Access Compliance Report

Public Rights-of-Way

(Curb Ramps)

Intersection ID: 28029	Main Street: BAY_HILL_CLUB_DR	Cross Street: PINE_VALLEY_CLUB_DR	Location: SW
ADA ID: 1B4C1618BA99	Ramp Type: Perp	Initial Pass/Fail: Pass	Overall Compliance: No
Codes/Mitigation Info/Possible Solution		Field Measurements/Component Compliance	
Severity Score: 15

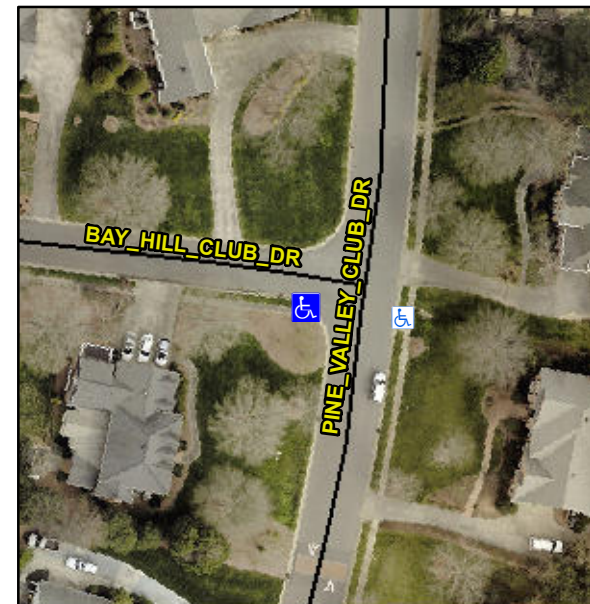
**Not Found, R304.2.1, R304.2.2-Perp,
R304.3.2-Para, R304.5.3, R302.7,
R304.5.4**

Compliance	Description	Data	Compliance	Description	Data
N/A	Ramp Length (in)	43.0	Yes	Ramp Slope (%)	5.1
Yes	Ramp Width (in)	48.0	Yes	Ramp XSlope (%)	0.9
N/A	Flare Type LT	Sloped	N/A	Flare Type RT	N/A
N/A	Flare Slope LT (%)	0.4	Yes	Flare Slope RT (%)	4.1
N/A	Flare Traversable LT?	Yes	N/A	Flare Traversable RT?	Yes
No	Landing Length (in)	N/A	Yes	DWS Provided?	Yes
No	Landing Width (in)	N/A	Yes	DWS Contrast?	Yes
No	Landing Slope (%)	N/A	Yes	DWS Length (in)	24.0
No	Landing X Slope (%)	N/A	Yes	DWS Full Width?	Yes
N/A	Landing Curb? (Y/N)	No	Yes	DWS Offset (in)	2.0
N/A	Shared Landing?	No			
No	Gutter Ponding?	Yes	No	Gutter Slope (%)	6.4
Yes	Gutter Lip Ht (in)	0.0	Yes	Gutter X Slope (%)	1.0
N/A	Painted X Walk1?	No	N/A	Painted X Walk2?	N/A
	X Walk 1 Direction	To SE		X Walk 2 Direction	N/A
N/A	X Walk 1 Width (in)	N/A	N/A	X Walk 2 Width (in)	N/A
	X Walk 1 Slope (%)	1.8		X Walk 2 Slope (%)	N/A
	X Walk 1 X Slope (%)	1.4		X Walk 2 X Slope (%)	N/A

**Remove & Replace Entire Ramp.
Remove & Replace Gutter.**
